MEMORANDUM

Document Number: J-H-NZ0238-013-M-Rev0

Document Title: BOGP FTAA Minute 53 Response

Hydro Geochem Group Limited (HGG) have prepared this memorandum in response to Minute 53 from the Bendigo-Ophir Gold Project (BOGP) Fast-Track Approval Application FTA-25 07-1089 Expert Panel.

Figure 1: Bedrock Gap and depth to bedrock.

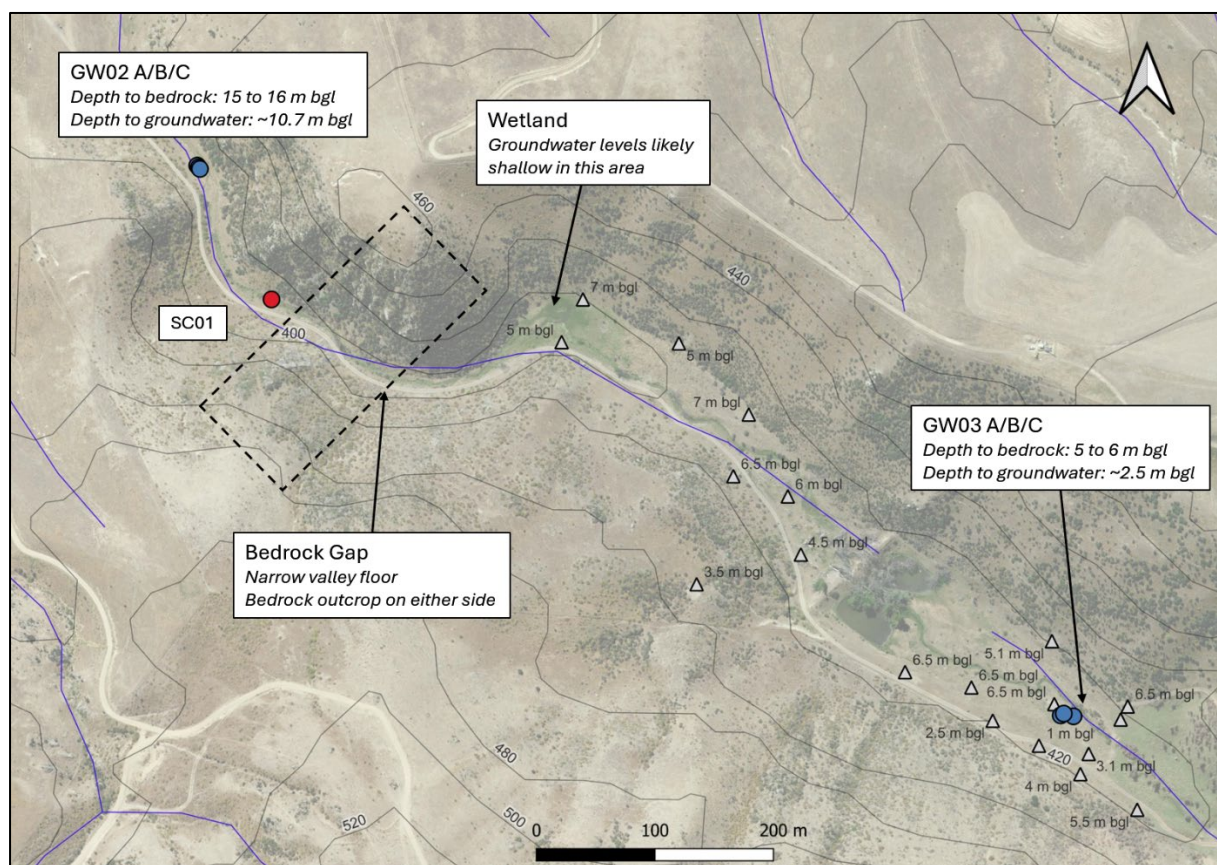
HGG appreciate the opportunity to provide this correction to calculations made on page 7 of HGG (2026). As pointed out by submitters¹, the calculated value for groundwater flow through the Alluvial Aquifer at GW03 should be 0.9 L/s and not <0.01 L/s which was the figure used. For the reasons that follow, we confirm the calculation error does not change our opinion expressed in HGG (2026), which concluded that that most unrecovered seepage is likely report to SC01.

The calculation was used as one of multiple lines of evidence and assessment to interpret the hydrogeological conditions at the Bedrock Gap (Figure 1) based on available data. These lines of evidence are repeated here for clarity:

- Bedrock outcrops on the valley sides at this location, indicating a shallow depth to bedrock (or thinner Alluvial Aquifer) than seen at GW03. This location has a narrow valley floor compared to other areas within the Shepherds Creek valley, indicating a smaller width Alluvial Aquifer than seen at GW03. It is noted that elsewhere within Shepherds Creek where the valley floor is comparably narrow, depth to bedrock is in the region of 2-3 m below ground level (Figure 2).

- This valley geometry indicates a reduction in the interpreted Alluvial Aquifer cross-sectional area between GW03 and the Bedrock Gap by a factor of 5 assuming an aquifer thickness of 7 m. Assuming an aquifer thickness of 3 m (as seen elsewhere in the catchment with a narrow valley floor) would reduce the cross-section area by a factor of approximately 10².

- A wetland area is present immediately upstream of the Bedrock Gap, suggesting shallow groundwater levels consistent with a reduction in aquifer cross-sectional area that lowers the capacity for groundwater flow.

In summary, there are multiple lines of credible evidence to suggest that the Bedrock Gap, or area immediately upstream of it near the wetland, is likely a current zone of groundwater discharge. When considering all the available evidence referred to above together, the change in calculated groundwater flow rate of 0.9 L/s does not materially alter that conclusion nor my opinion that most unrecovered seepage would report to SC01.
